**RE: 236 Las Miradas Drive**

I reviewed the drawings, evaluated the neighborhood context and reviewed the initial design in February of 2017. My comments and recommendations on the new design submittal are as follows:

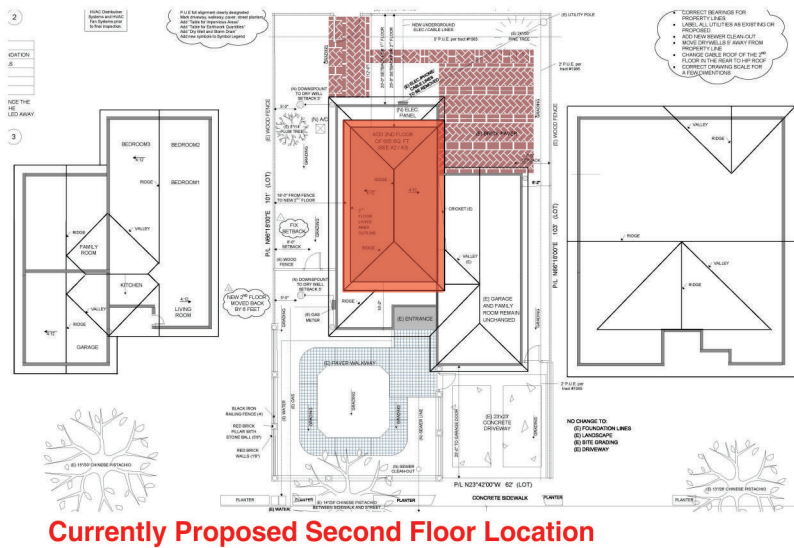
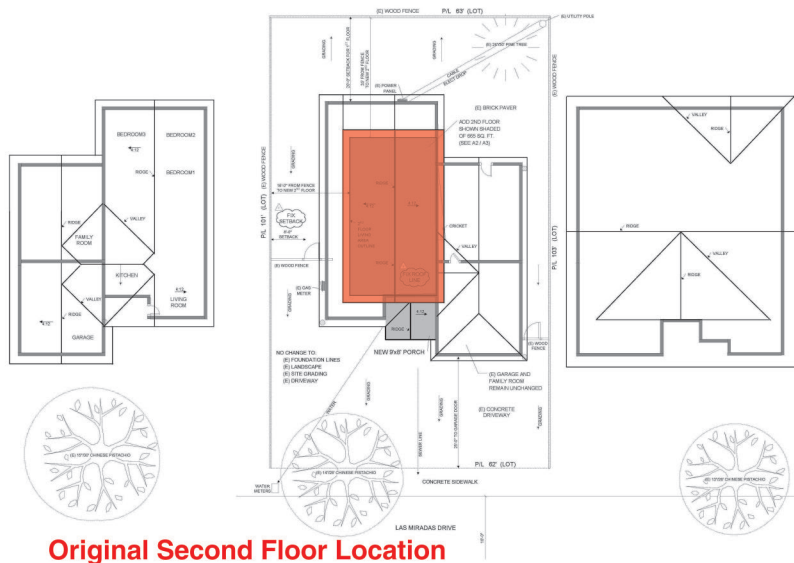
1. The most significant change has been the relocation of the second floor away from the front setback - see site plan comparison below and left side elevation comparison on page 7.

#### CURRENT FRONT ELEVATION COMMENTS

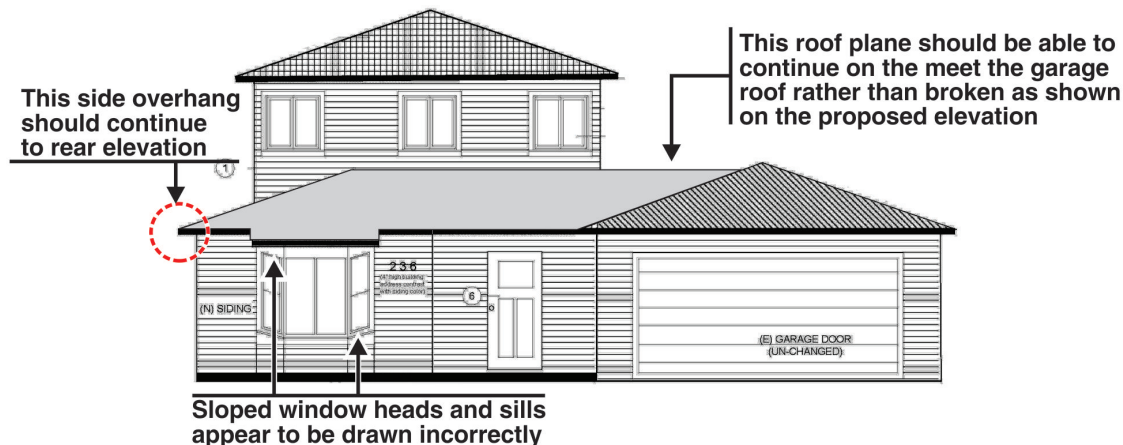
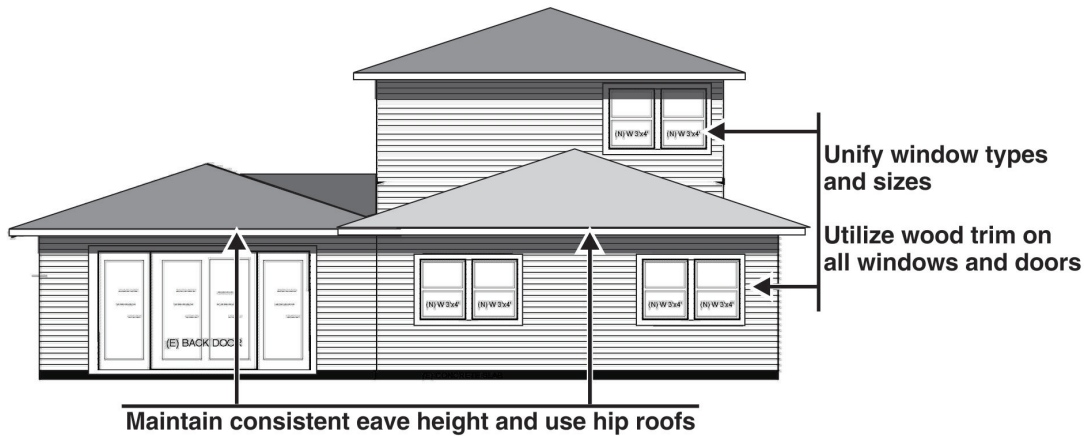
#### Front Elevation Issues

- The relocation of the second floor building mass may not result in the best design.
- Attempts to retain the current saddle roof between the house and the garage would result in an awkward transition of roofs on the front elevation.

- Consider retaining the second floor mass in its previous original location rather than moving it to the rear. The distance that the second floor would be moved would not materially change the earlier two-story mass issue which was identified, and the overall design would be less unified.
- Provide a single plane for the first floor roof to intersect with the garage roof.
- Correct the head and sill lines of the bay window.

#### CURRENT REAR ELEVATION COMMENTS

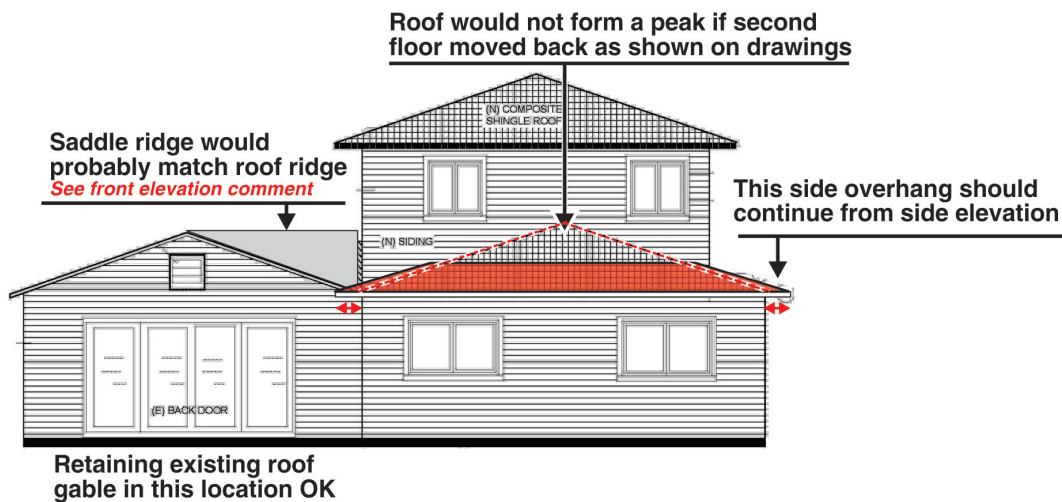
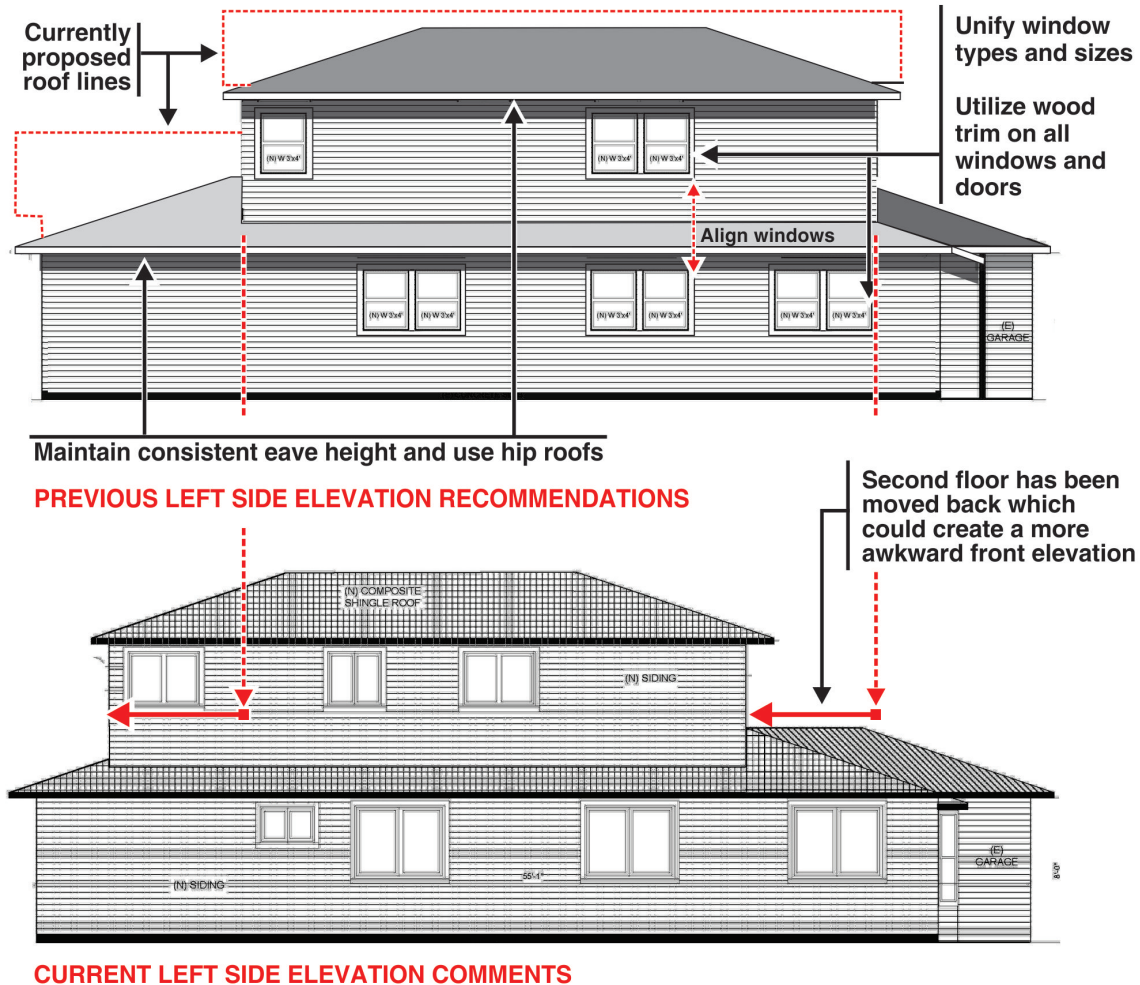
##### Rear Elevation Issues

- The first floor roof on the right side of the facade has been drawn incorrectly. Moving the second floor mass further to the rear of the house would not allow a full hip roof form.
- The roof overhangs on the sides of the building form projecting to the rear of the site have been omitted.

- Provide first floor roof overhangs to match the side elevations.
- The applicant did not change the roof form over the first floor Family Room to a hip roof rather than the existing gable form. However, the applicant provided an explanation and a request to retain the existing gable roof. I found the request reasonable, and I would have no recommendation for changes to that roof.
